Location:	Skyline Boulevard, south of Roberts Park street entrance at AC Transit bus stop (see map on reverse)
Assessor's Parcel Number:	None
Proposal:	To install a 25-ft. Monopole Telecommunications Facility consisting of a 2'-8" antenna attached to a 22'-4" pole that would replace an AC Transit bus stop sign.
	On August 4, 2010 the Planning Commission denied a previous design (#CM10140) and on November 9, 2010 the City Council denied an Appeal (#A10224); this application is for a new design
Applicant/	Sharon James / NextG (for Verizon)
Phone Number:	(408) 426-6629
Owner:	City of Oakland
Planning Permits Required:	Major Conditional Use Permit with two (2) sets of additional findings to allow a Monopole Telecommunications Facility in the Open Space Zone
General Plan:	Urban Open Space
Zoning:	OS (RSP) Open Space (Region-Serving Park) Zone
Environmental	Exempt, Section 15270 of the State CEQA Guidelines:

The applicant Ms. Sharon James of NextG (for Verizon) requests Planning Commission approval of a Major Conditional Use Permit with two (2) sets of additional findings to install a twenty-five (25) foot tall Monopole Telecommunications Facility consisting of a 2'-8" antenna attached

View # 1g

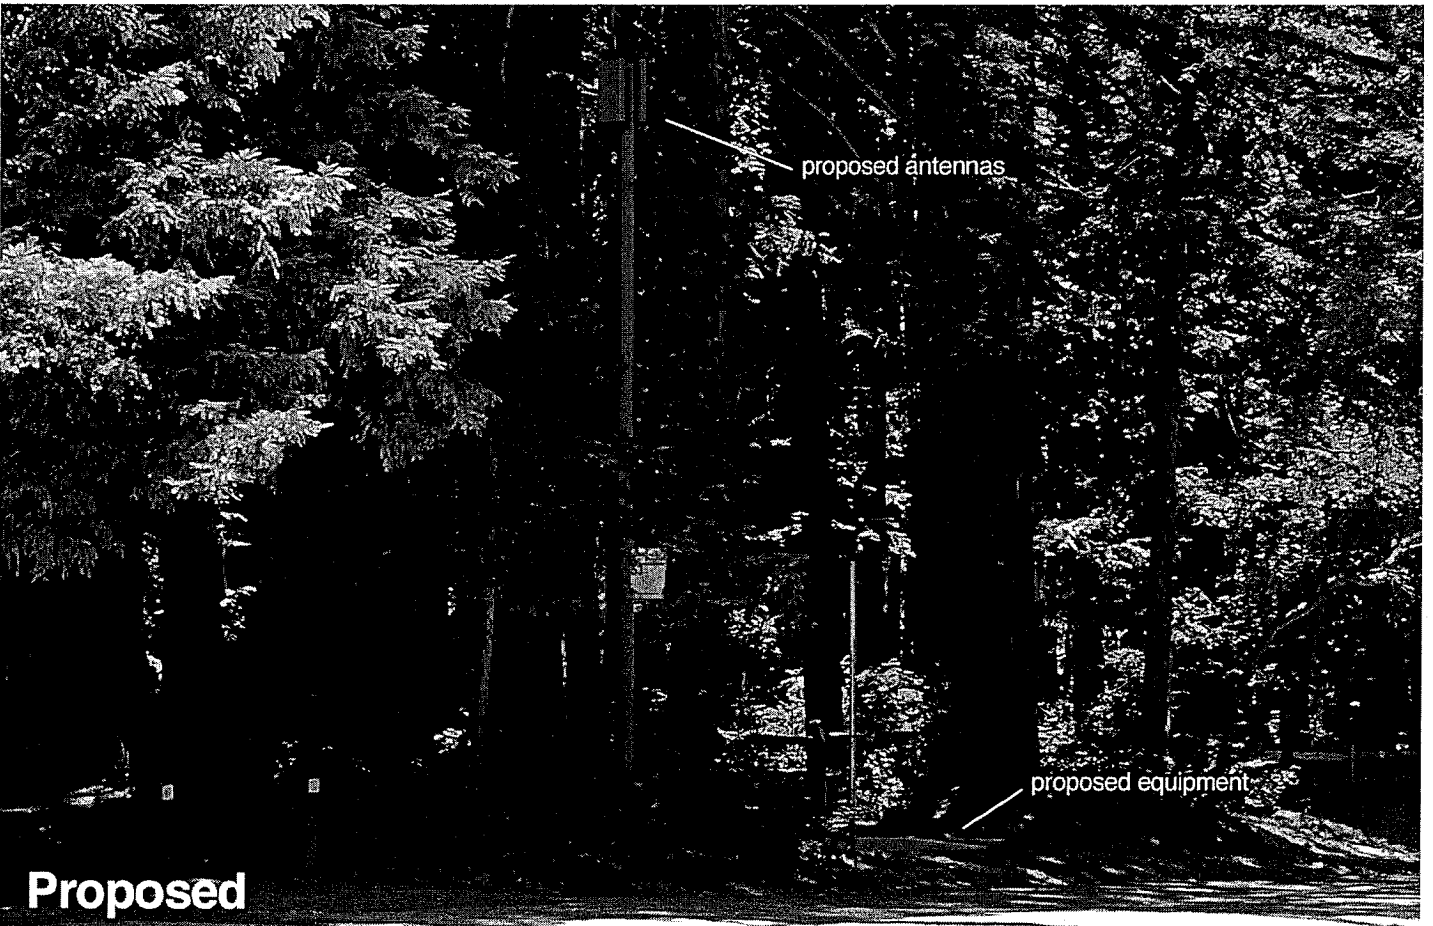
The Monopole would not be screened; it would be ten-feet from the road and twenty-five (25) feet in height in an area where no other structures similar in height exist, and would modify (replace) a bus stop sign that is only 9'-6" in height.

The unconcealed tall monopole would be incompatible with the area consisting of open space with parks lacking tall manmade structures. The proposed structure would not preserve open space and would not be compatible with the unbuilt natural environment in the area. The design is relatively tall and the area does not contain any other large poles such as telephone poles or telecommunications monopoles. The existing bus stop sign is only 9'-6" tall, so placing a bus stop sign on a new pole that is 25-feet in height is a significant change in appearance that would adversely affect the relatively pristine visual character. The tall pole is not necessary to support the bus stop sign.
